Hennepin County Transportation Department

ADDENDUM

ADDENDUM NO. 4

CSAH 61; C.P. 0904
S.A.P. 010-661-003, 027-661-048,
181-020-031, 194-020-012

DRAINAGE DETAIL - CATCH BASIN AND MANHOLE OFFSET

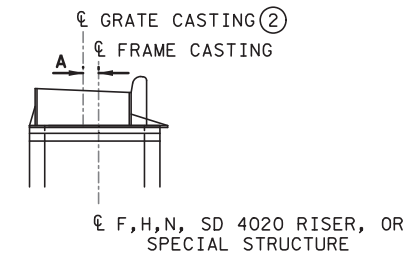
REVISION		
DATE	DESCRIPTION	APPROVED BY
11/07/2017	1) UPDATED QUANTITY FOR CASTING ASSEMBLY	HZ
